NOTICE OF VIOLATION

On August 8, 2023, Energy Safety conducted an inspection of PacifiCorp WMP initiatives in the vicinity of the city of Happy Camp, California. The inspection report is enclosed herewith. Energy Safety found the following violation:

INSPECTION REPORT

Item1G: Overall pole.

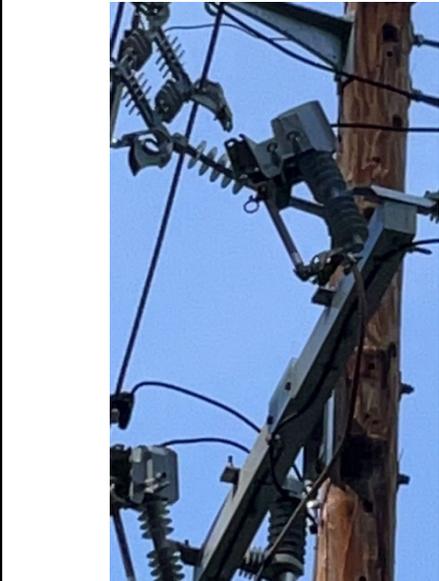
On pole ID 07116007.0112804 at 5 Attebery St, Happy Camp, CA 96039, USA, 41.7969133438358, -123.380378228127, the inspector observed expulsion fuses on the pole. The inspector's observation is documented in Violation 1 photographs, which are attachments to this report. Photo numbers Item1GIimg1, Item1GIimg2, and Item1IA1img1 depict expulsion fuses on the subject pole where PacifiCorp reported installing non-expulsion fuses.

1. PacifiCorp's WMP expulsion fuse replacement work was identified as complete at this location.
2. The subject pole is in HFTD Tier 2.
3. PacifiCorp failed to replace expulsion fuses with CAL FIRE-approved non-expulsion fuses.
